Re: Railway (Metrolink - Estuary to Charlemont via Dublin Airport) Order [2022]
Metrolink. Estuary through Swords, Dublin Airport, Ballymun, Glasnevin and City Centre to
Charlemont, Co. Dublin

RE: SUBMISSION ON THE METROLINK ON BEHALF OF EARLSFORT BASIN LTD, (PREVIOUSLY EARLSFORT VENTURES LTD) IN RELATION TO PROPERTY AT 15-18 EARLSFORT TERRACE, DUBLIN 2

Project Title	Project Metrolink – 15-18 Earlsfort Terrace, Dublin 2	From	Robert Coughlan, PUNCH Consulting Engineers
Project No	222261	To	An Bord Pleanála
Subject	Technical Submission to Railway (Metrolink–Estuary to Charlemont via Dublin Airport) Order 2022 at – 15-18 Earlsfort Terrace, Dublin 2	Cc	
Date	12-01-2023

**Appendix B- Volume 4, Chapter 20- Fig 20.16, sheet 29
of 30**

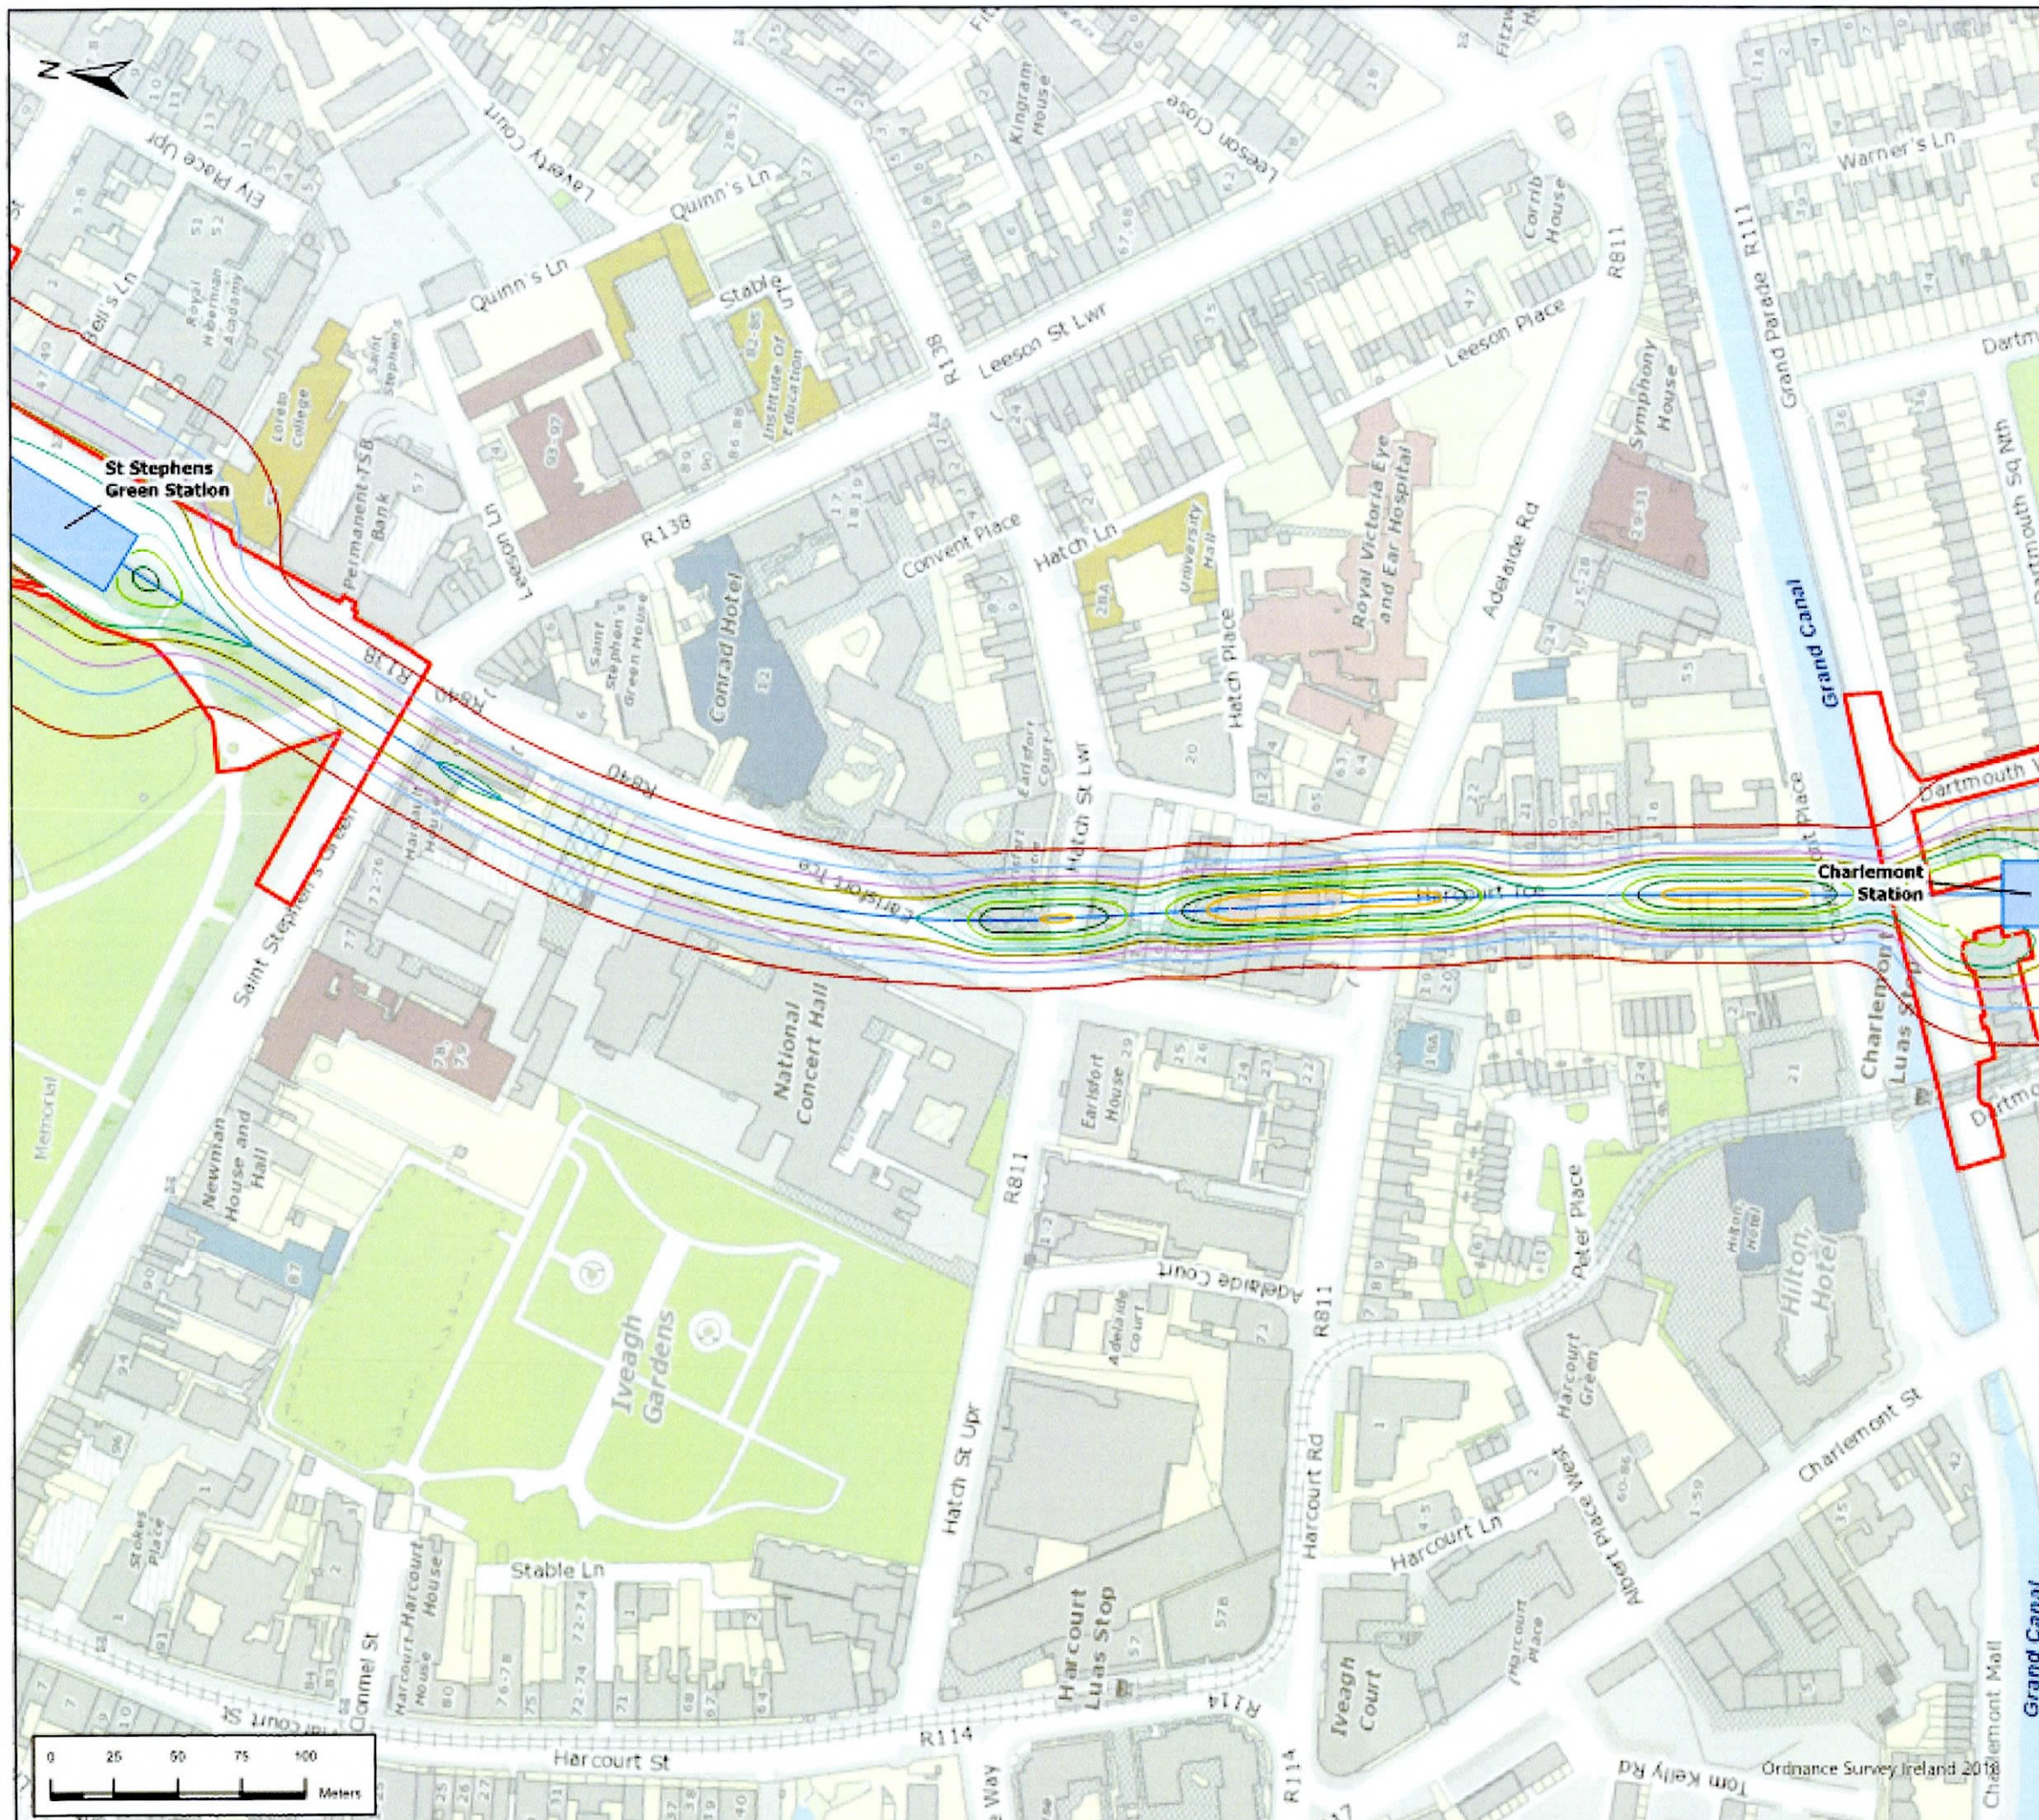
- i) The predicted settlement is a concern from available information on <https://www.metrolinkro.ie/>. The settlement contours on Figure 20.16, sheet 26 of 30 (Refer to Appendix B), suggest settlement up to 25mm in the calculated settlement trough. We request details from TII on how they established this deflection data. The building is a Protected Structure and over 130 years and TII must recognise this.

Appendix D – Figure 12.2, Sheet 29 of 30, Construction Noise Assessment Locations

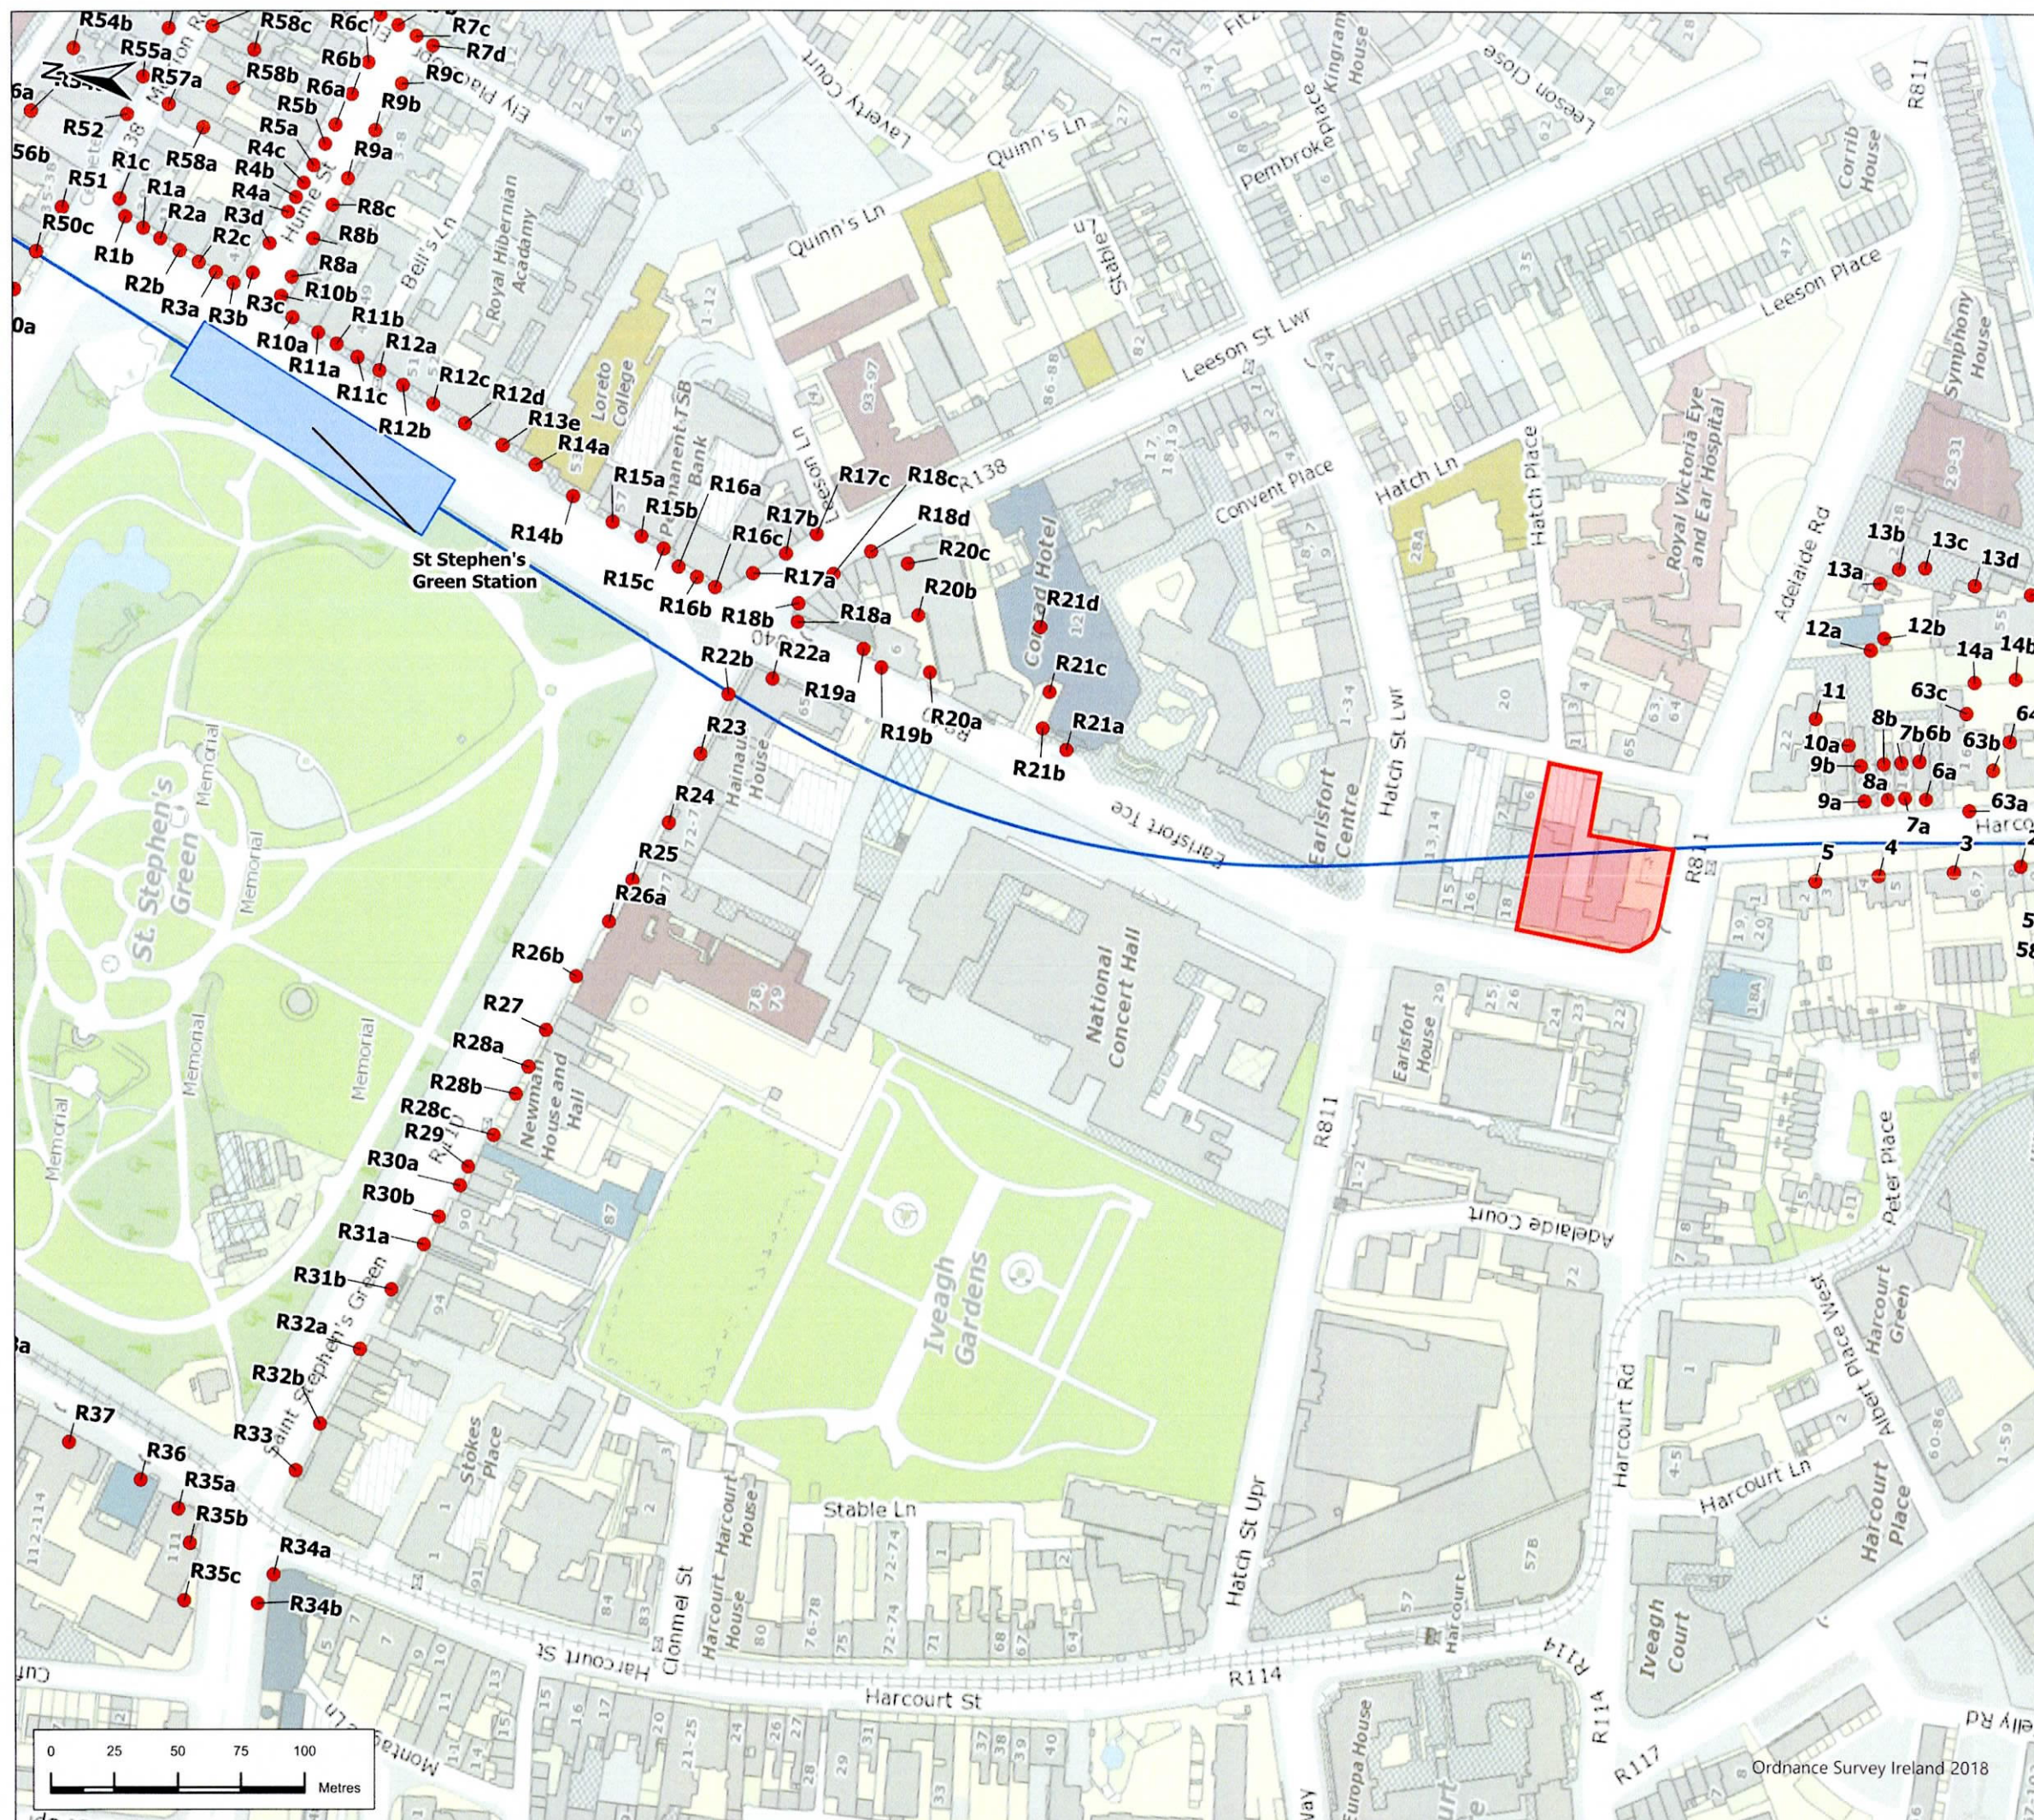
- iv) A further area of concern is Figure 12.2, Sheet 29 of 30, Construction Noise Assessment Locations (Refer to Appendix D) which shows there were no construction noise receivers placed on or surrounding our clients building. This is a huge concern as we cannot see how the predicted noise limits can be determined without a noise receiver on our client's building or surrounding buildings.
